CITY OF MOBILE
THREE MILE CREEK GREENWAY TRAIL LIGHTING - SEGMENT 1
& JAPANESE GARDENS PARKING LOT LIGHTING

Project No. 2025-2045-01

ADDENDUM #2

ELECTRICAL SITE PLAN

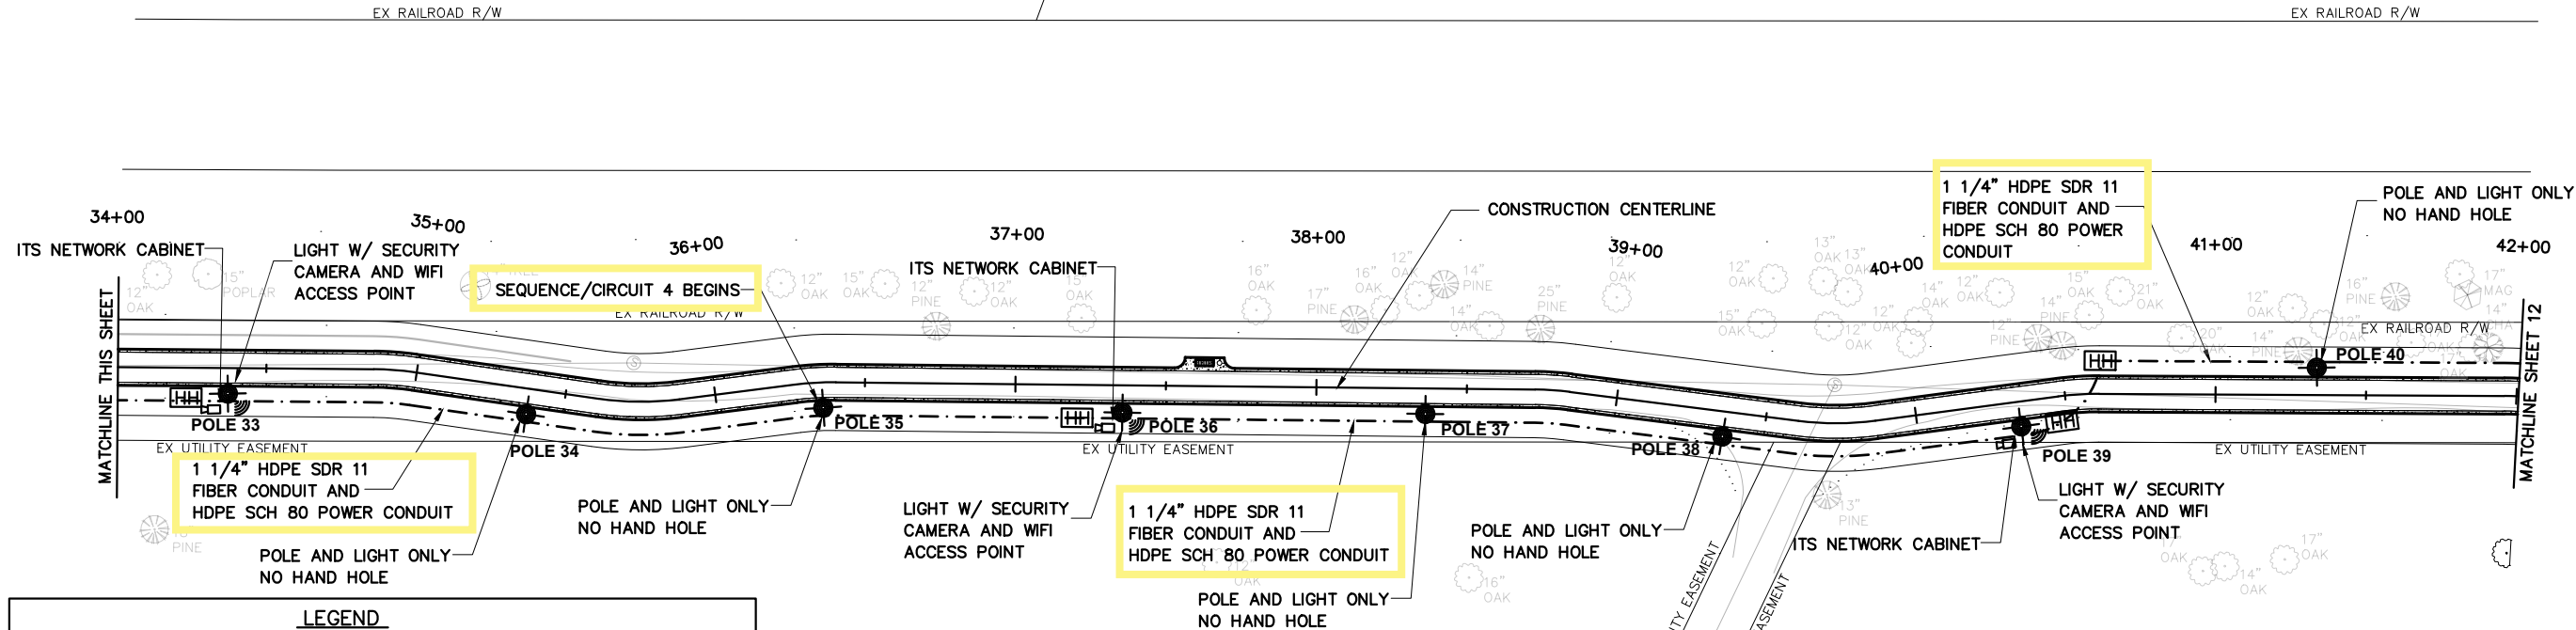
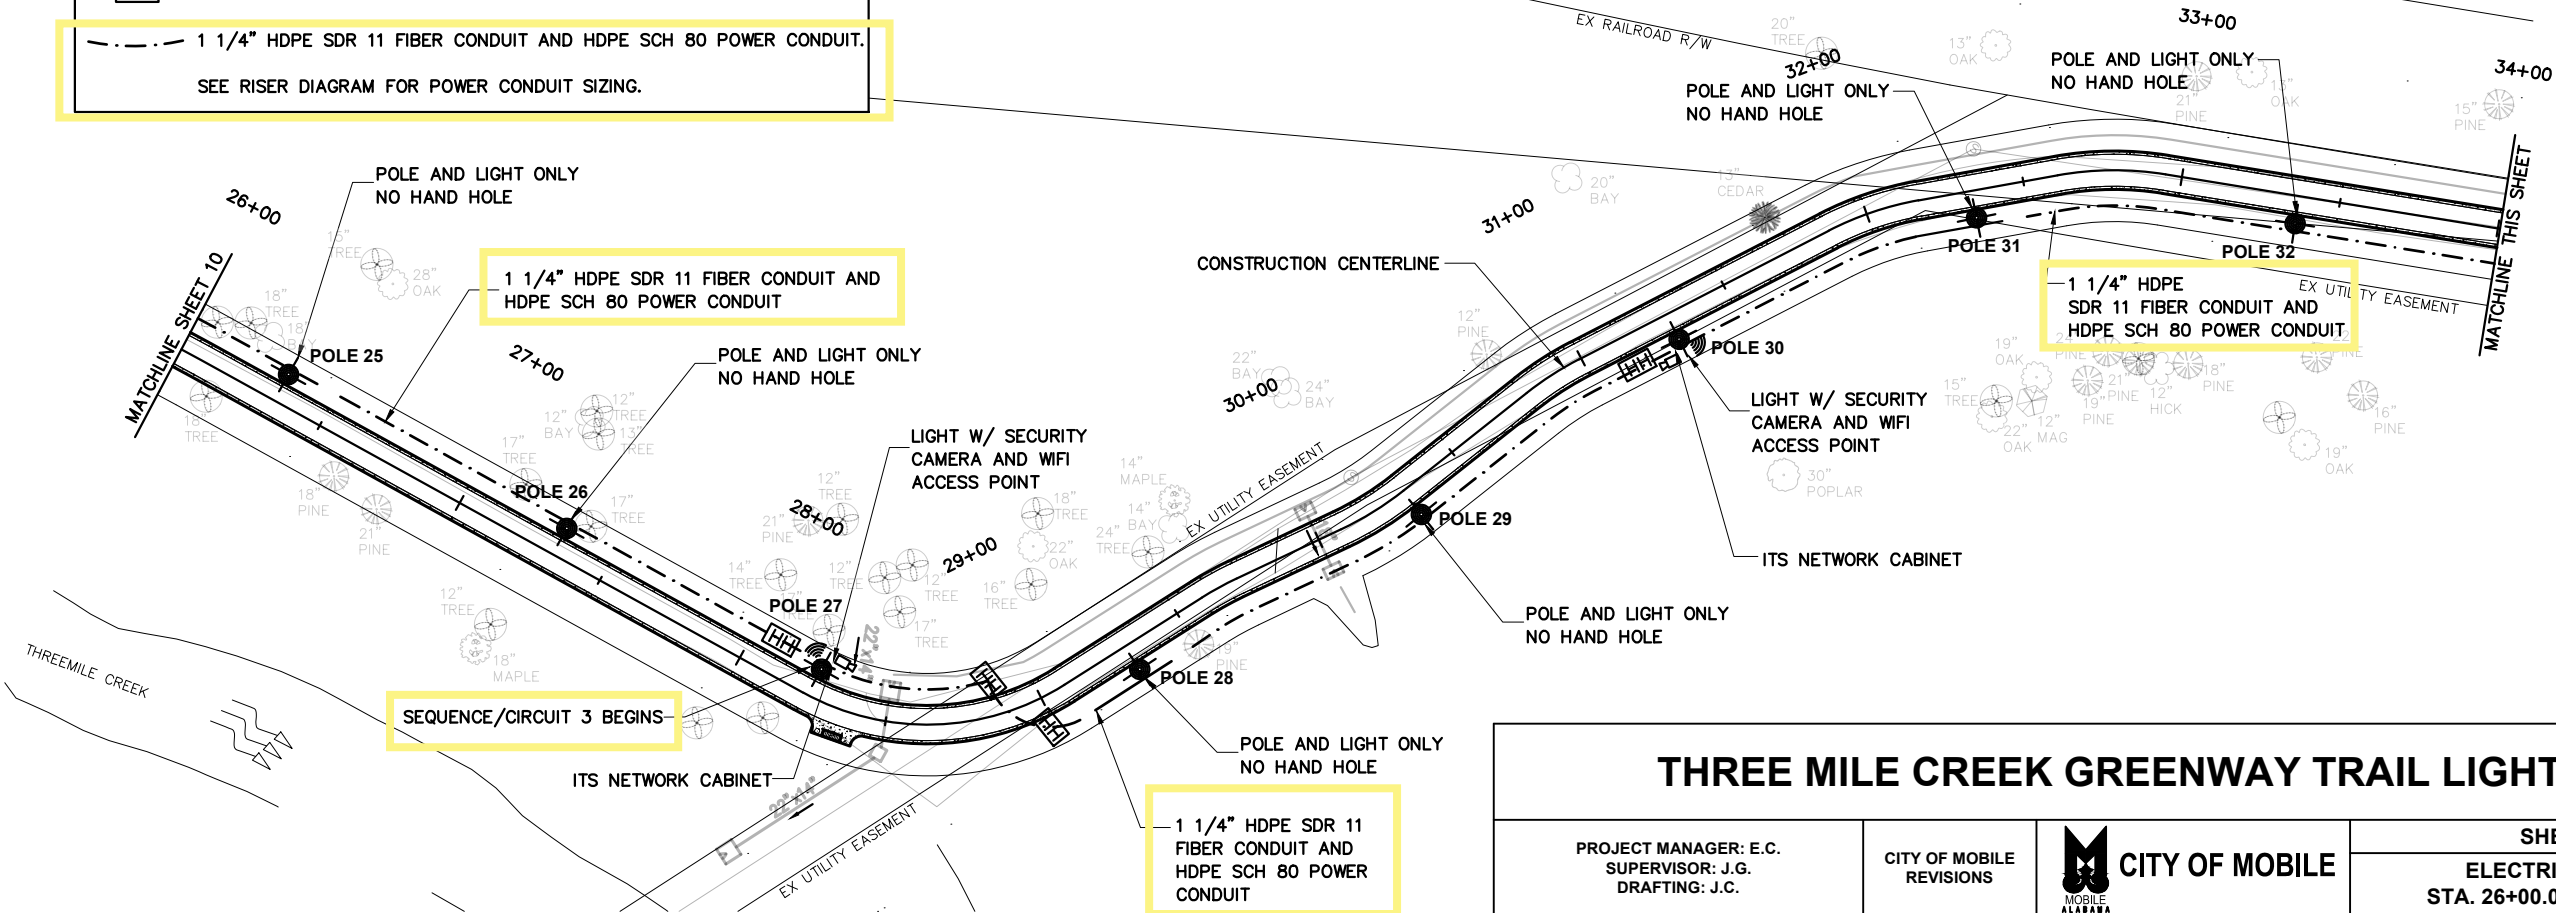
- Legend updated with, “1 1/4" HDPE SDR 11 FIBER CONDUIT AND HDPE SCH 80 POWER CONDUIT. SEE RISER DIAGRAM FOR POWER CONDUIT SIZING.”
 - Six (6) callouts for Fiber and Power conduit updated to say “1 1/4" HDPE SDR 11 FIBER CONDUIT AND HDPE SCH 80 POWER CONDUIT.”

- Included callout for “SEQUENCE/CIRCUIT 3 BEGINS”
 - Included callout for “SEQUENCE/CIRCUIT 4 BEGINS”
- Page 16 of 17, ELECTRICAL SITE PLAN 42+00.00 TO 43+16.10

- POLE AND LIGHT ONLY
- LIGHT W/ WIRELESS ACCESS POINT & SECURITY CAMERA
- HANDHOLE BOX
- NETWORK HUB CABINET
- POWER DISTRIBUTION SYSTEM
- 1 1/4" HDPE SDR 11 FIBER CONDUIT AND HDPE SCH 80 POWER CONDUIT. SEE RISER DIAGRAM FOR POWER CONDUIT SIZING.

ELECTRICAL SITE PLAN

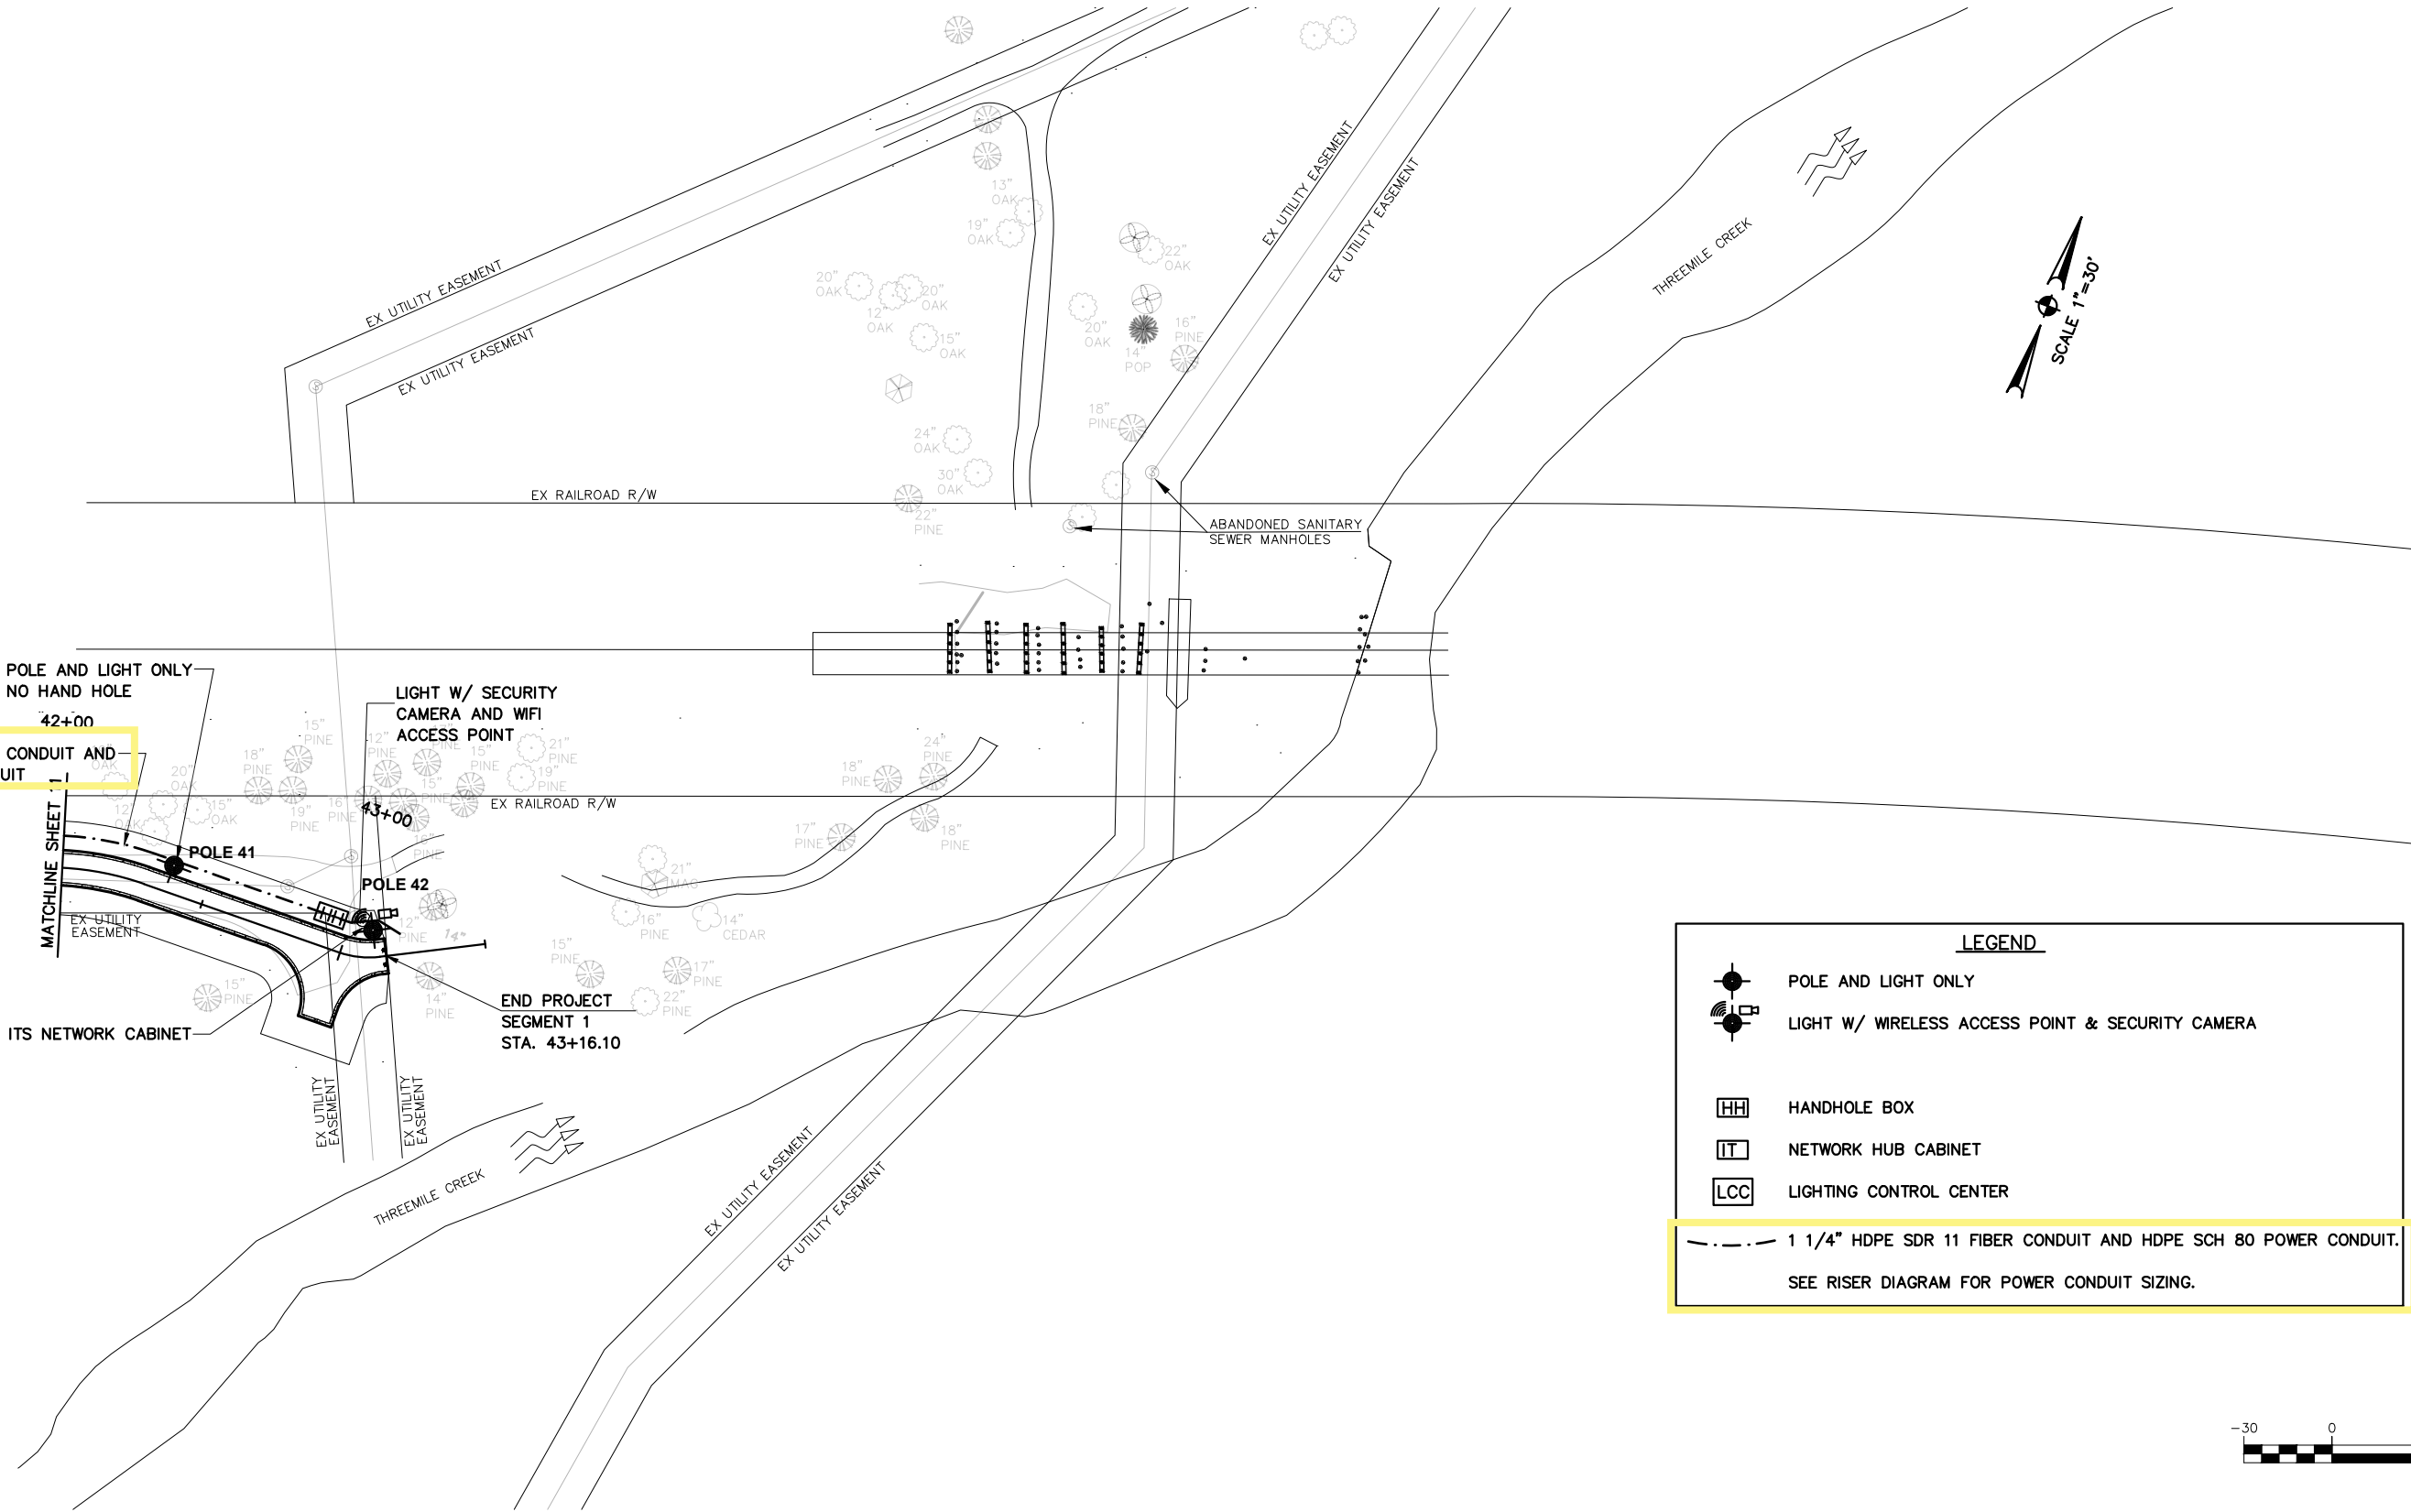
- Legend updated with, “1 1/4" HDPE SDR 11 FIBER CONDUIT AND HDPE SCH 80 POWER CONDUIT. SEE RISER DIAGRAM FOR POWER CONDUIT SIZING.”
 - One (1) callout for Fiber and Power conduit updated to say “1 1/4" HDPE SDR 11 FIBER CONDUIT AND HDPE SCH 80 POWER CONDUIT.”

RISER DIAGRAM

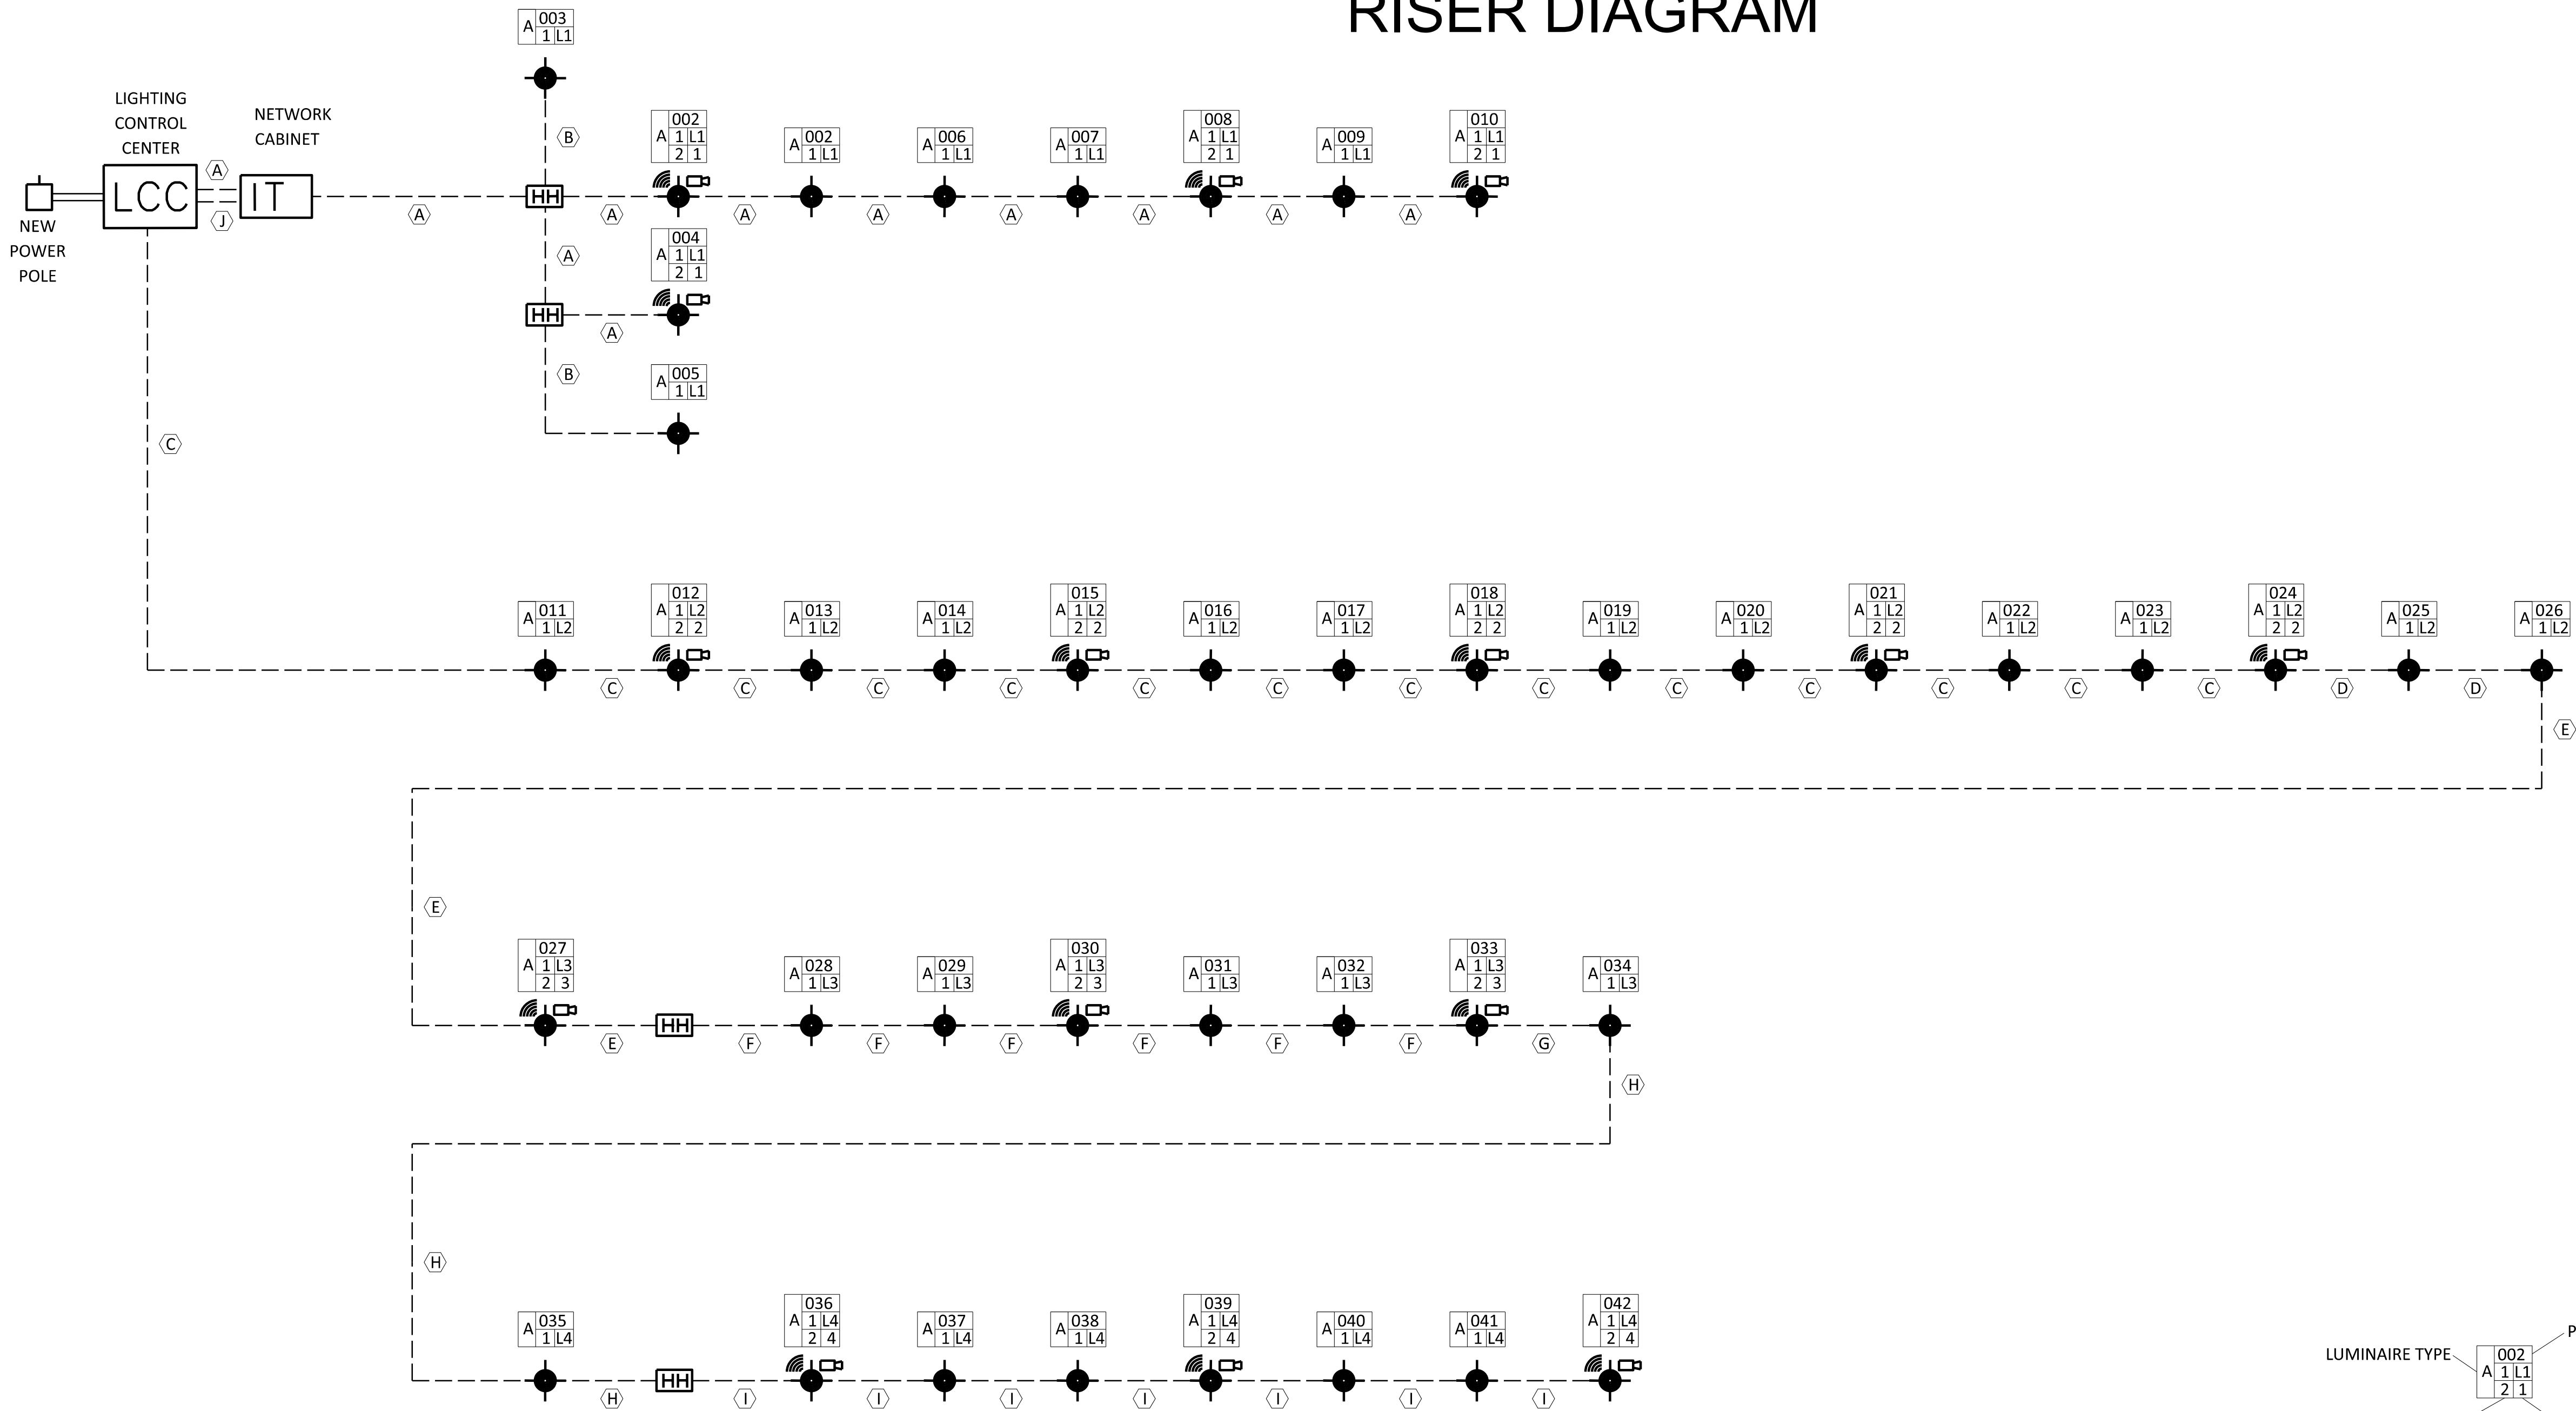
- Page 17 of 17, RISER DIAGRAM SHEET
 - Added RISER DIAGRAMS
